SUMMIT K2 CHARTER SCHOOL OPERATIONAL EXPANSION PROJECT

Final Subsequent Environmental Impact Report

SCH No. 2015112047

June 2016

Figure 3.3: Proposed Improvements to School Driveway Intersection, Sheets 1 and 2

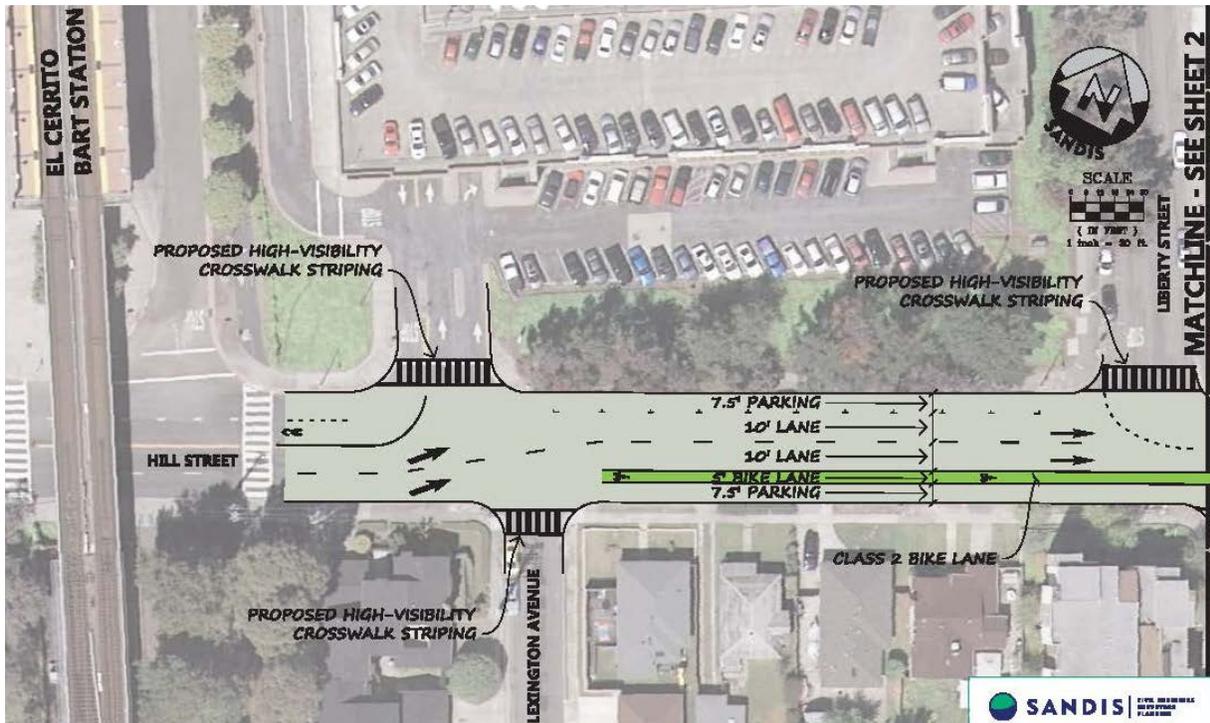
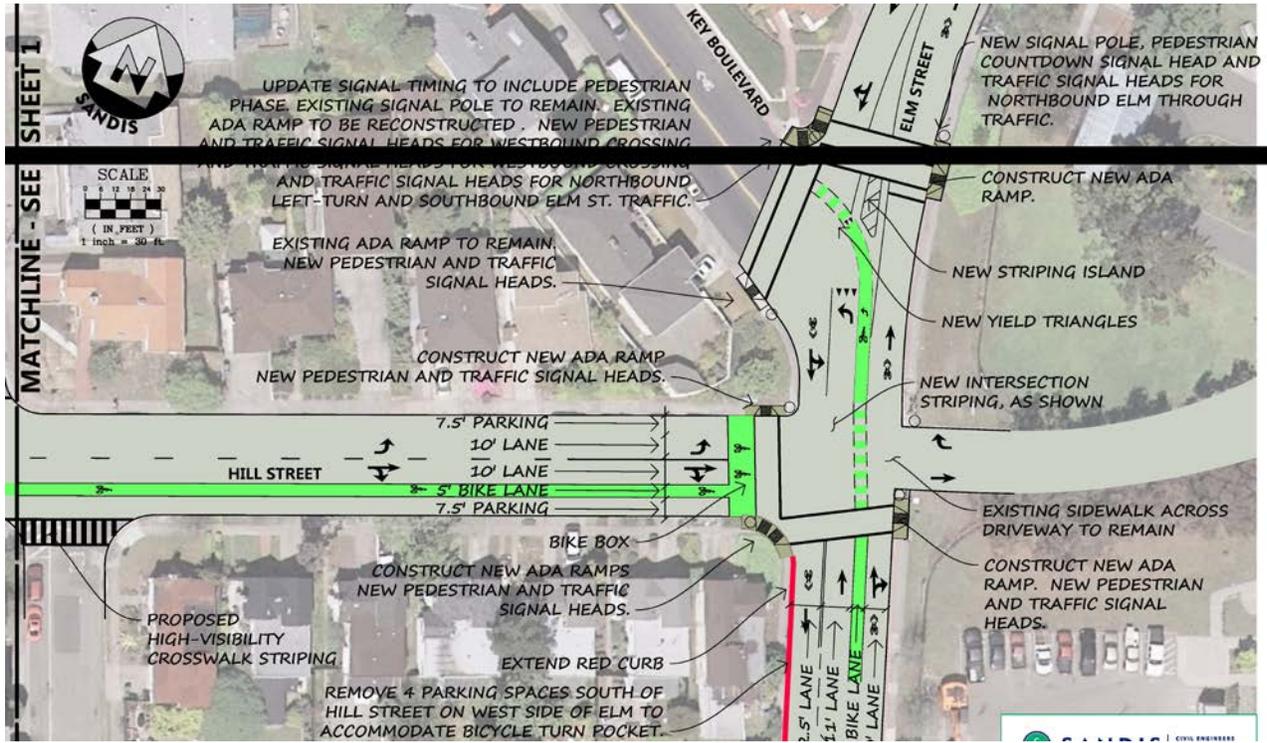
The discussion of the proposed school driveway intersection improvement is hereby revised in response to comments and staff-initiated revisions to clarify that improvements are consistent with the El Cerrito Active Transportation Plan and may require replacement of signal heads/hardware. Figure 3.3 is also hereby replaced with the following figures to show replacement of signal heads/hardware and additional detail of the bike lane beyond the adjacent intersection.

As a part of the Project, improvements to intersection operation with respect to pedestrians and bicycles would be made at and around the school driveway intersection (at Elm Street/Hill Street/Key Boulevard), as shown in **Figure 3.3**. These improvements are consistent with the El Cerrito Active Transportation Plan (approved by City Council on April 5, 2016), including include removal of four on-street parking spaces on the west side of the south leg of the intersection and would not impede the operation of the intersection for vehicular traffic.

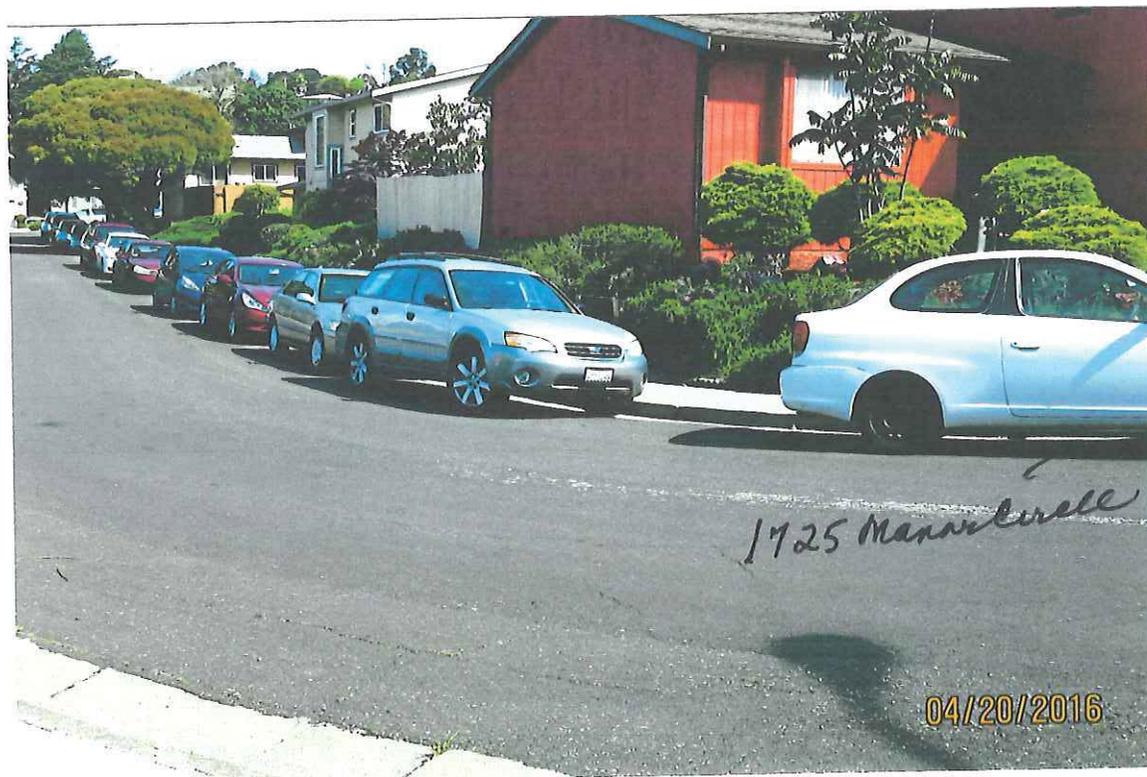
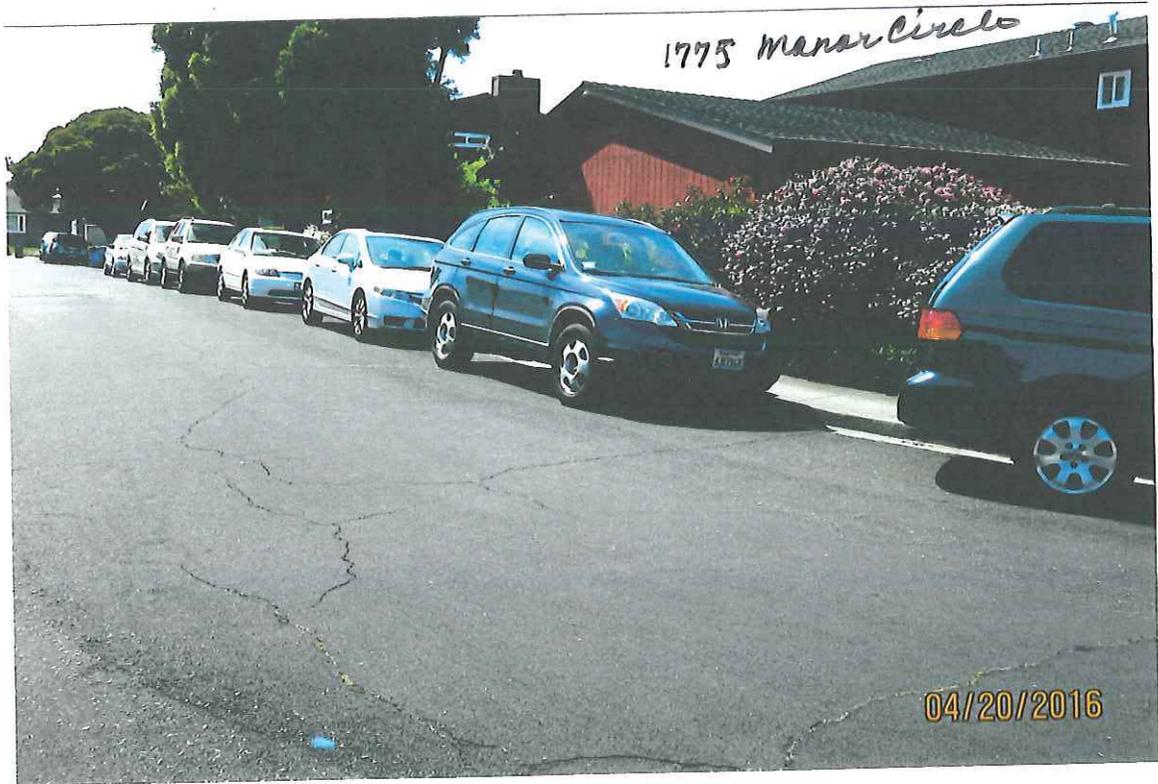
8. The Sandis diagram dated 12/22/2015, labeled Hill Street Safe Routes to School Conceptual Design, Figure 1, Sheet 1 of 2, indicates the existing ADA Ramp to Remain; existing Pedestrian Signal Heads to Remain. This ADA ramp is adjacent to our property, 1801 Key Blvd. The signal post constricts the ADA ramp access from the south side of the sidewalk. A mobilized wheelchair operator will not be able to negotiate this narrow sidewalk to access the ADA ramp to cross Key Boulevard's east-west crosswalk. This ADA ramp and the south access path need to be re-evaluated and possibly modified for accessibility. Two photos of the ADA ramp are attached. K-8
